ADDENDUM NO. 2

LOGANPORT FAIRVIEW ELEMENTARY SCHOOL RENOVATIONS
Logansport, IN 46947

ADDENDUM TWO

Addendum Two (AD.02) to the drawings and specifications prepared by Gibraltar Design and The Skillman Corporation for **Fairview Elementary School Renovations** for **Logansport Community School Corporation**, Logansport, Indiana.

S-104

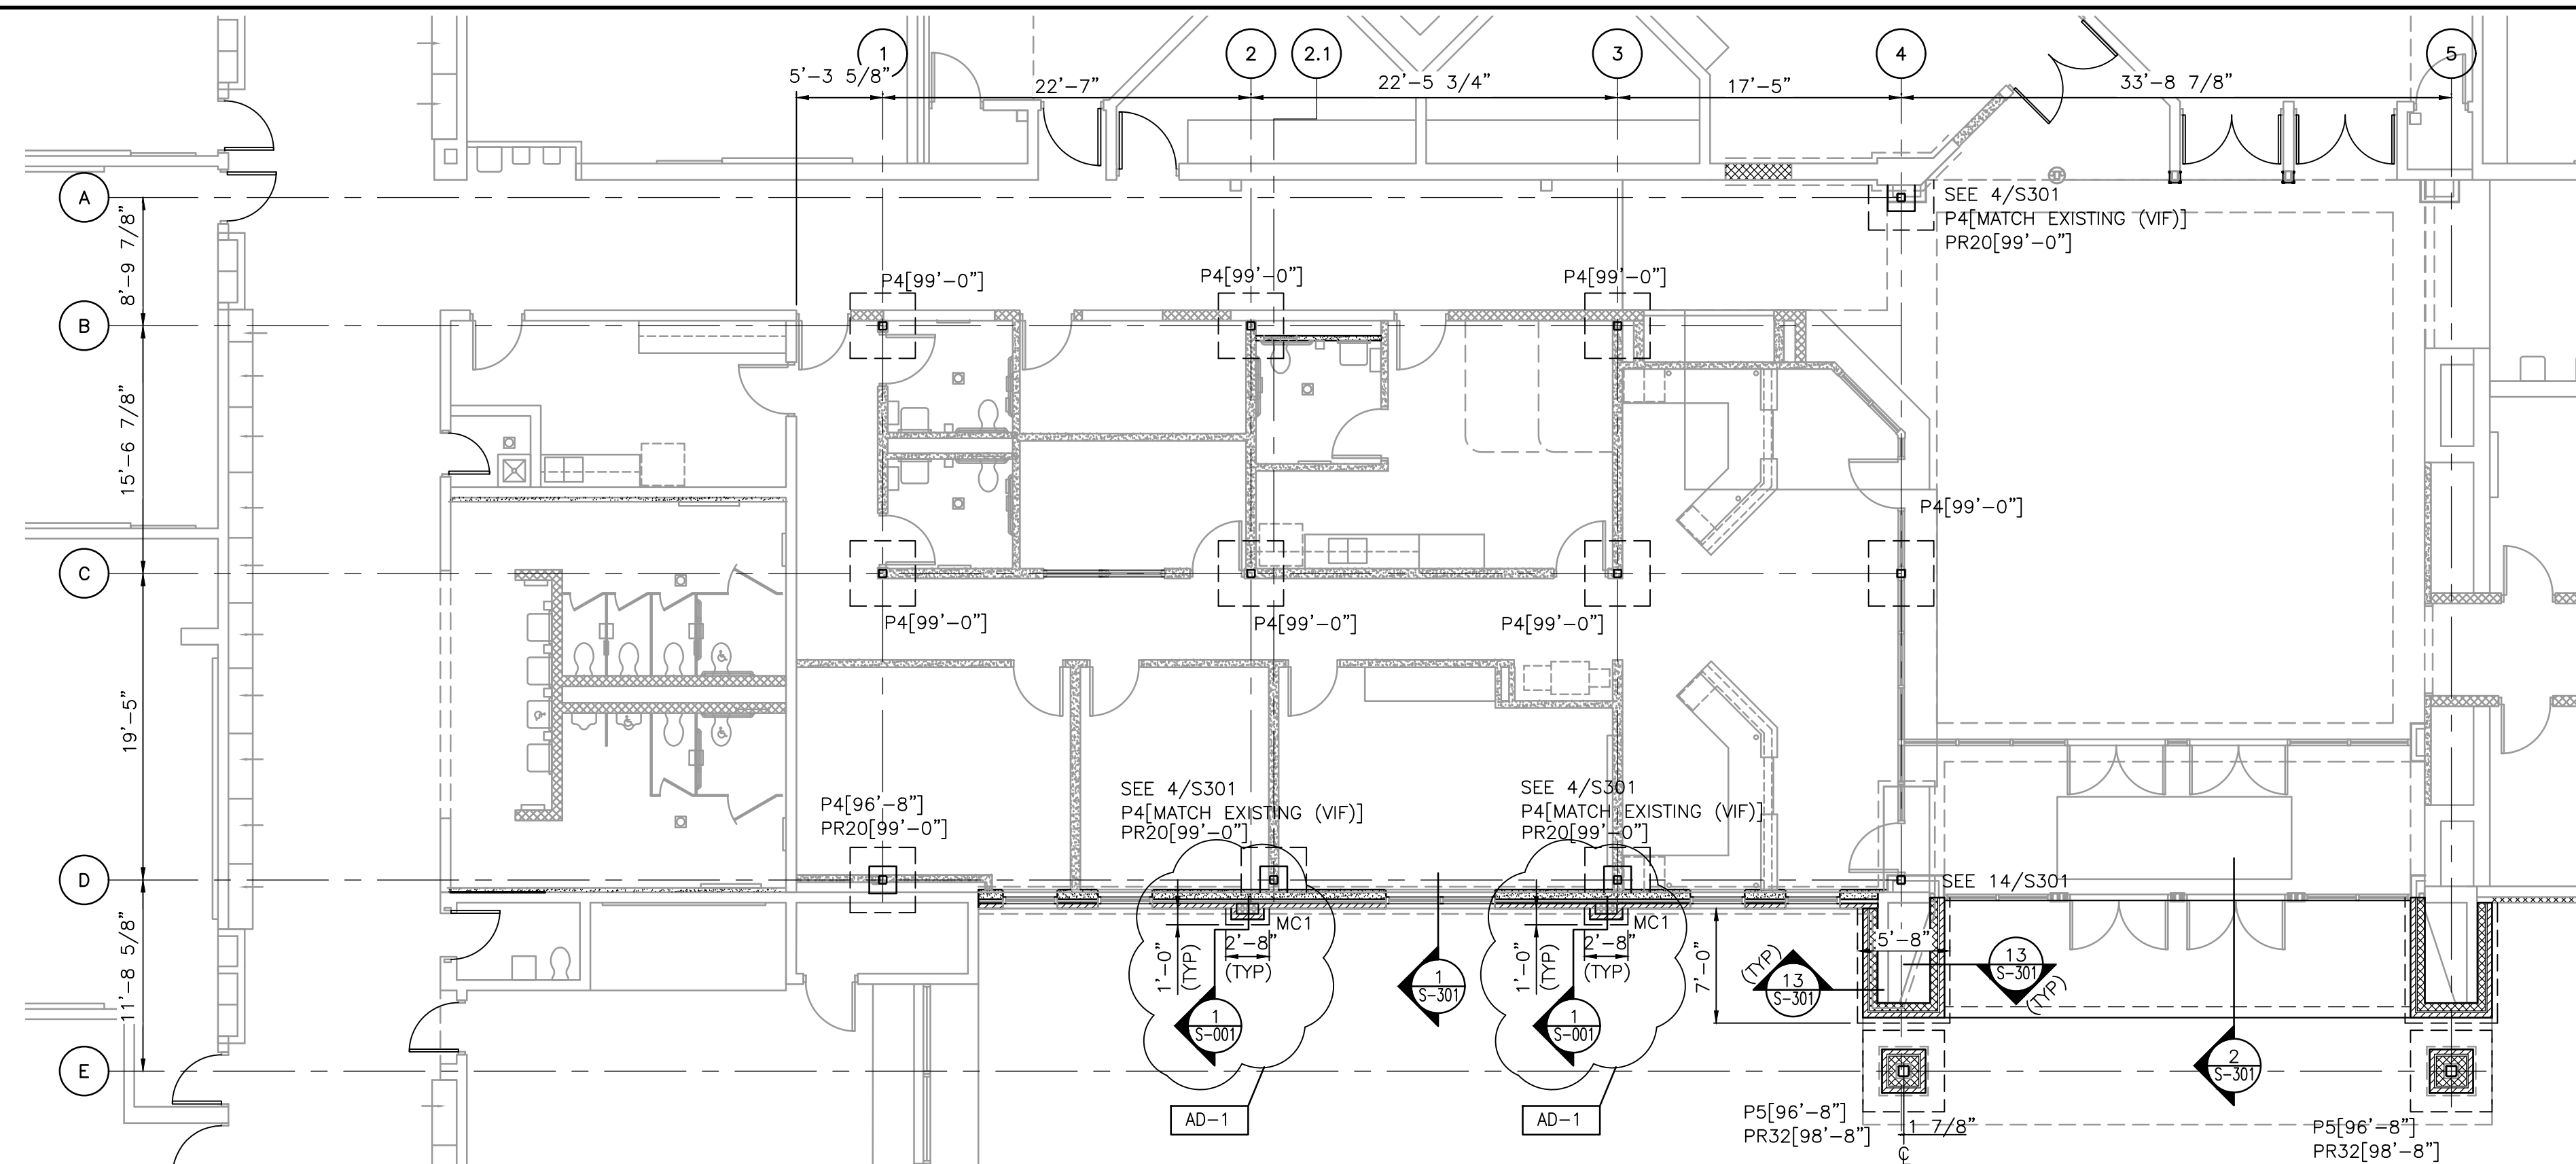
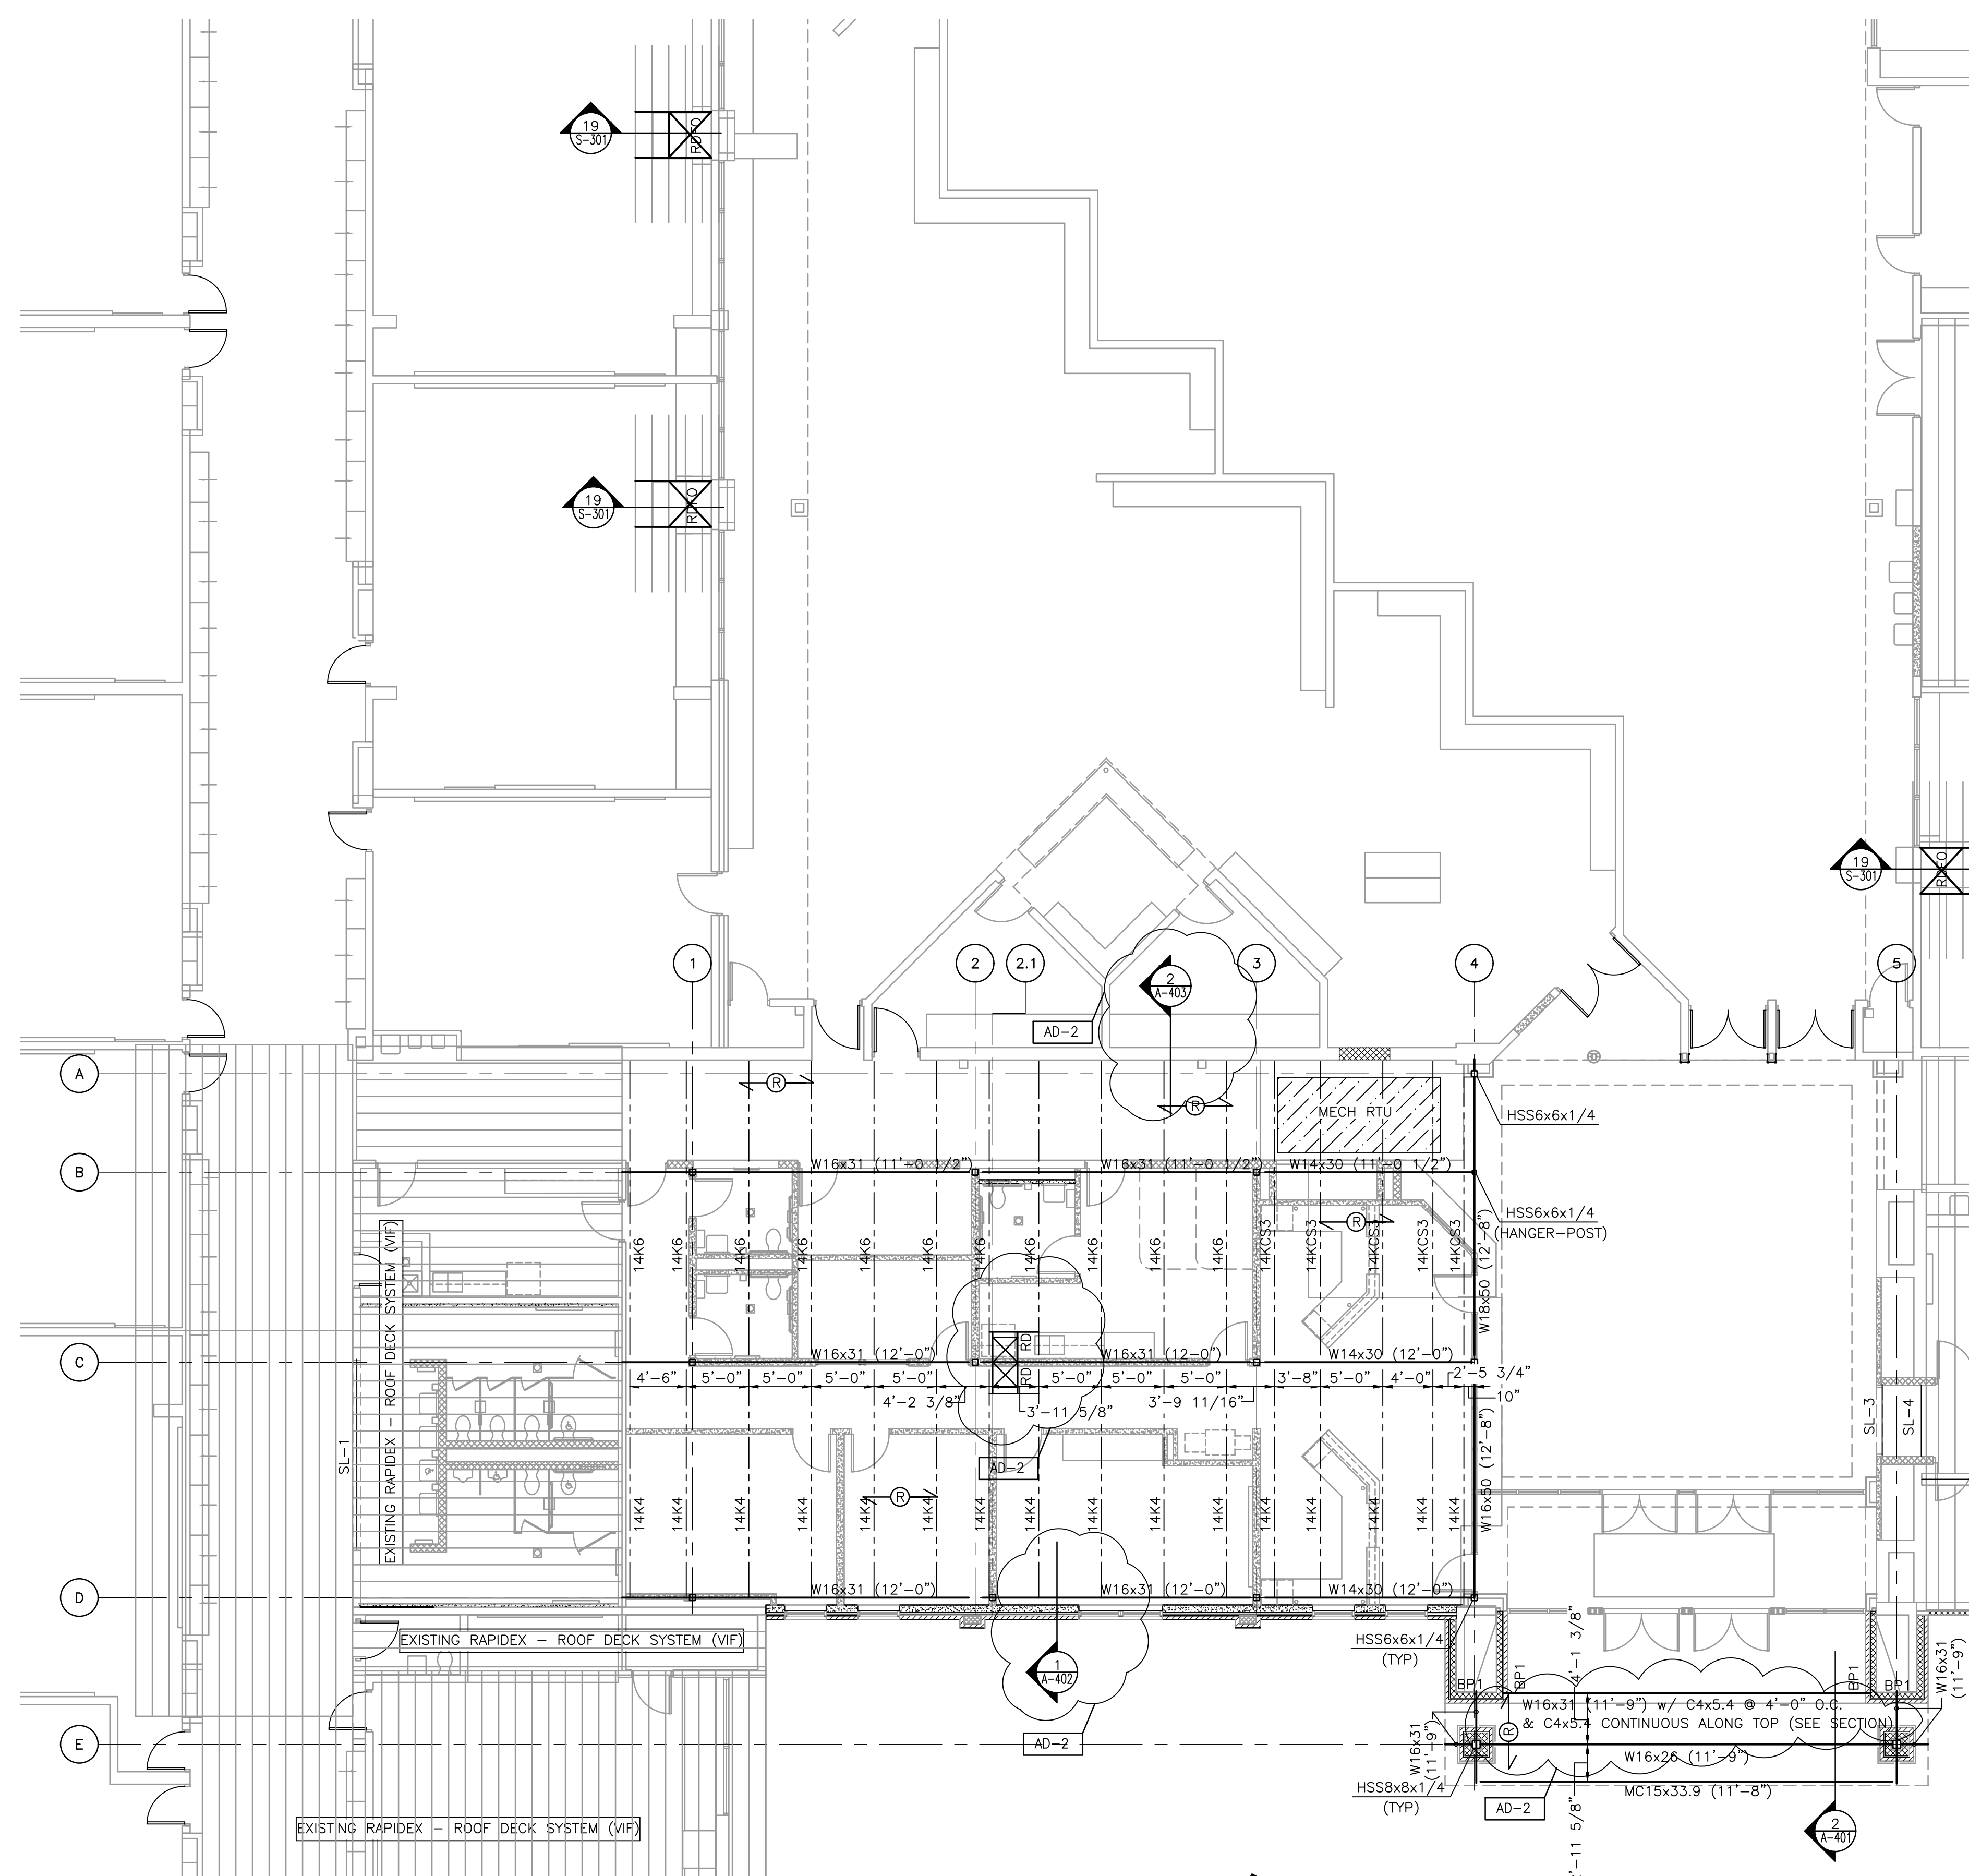
8. Sheet S-104

- A. Refer to revised full size drawing sheet, included in this addendum, for the following revisions:

1. Along Grid D, change Section Cut 2/A-401 to 1/A-402.
2. Add roof drain frame opening symbols along Grid C near Column Line 2.
3. Along Grid A, change direction of Section Cut 2/A-403 from facing right to facing left.
4. Down near Grid E at the newly revised entry canopy, add info about sizing top channel per Architectural Section 2/A-401.
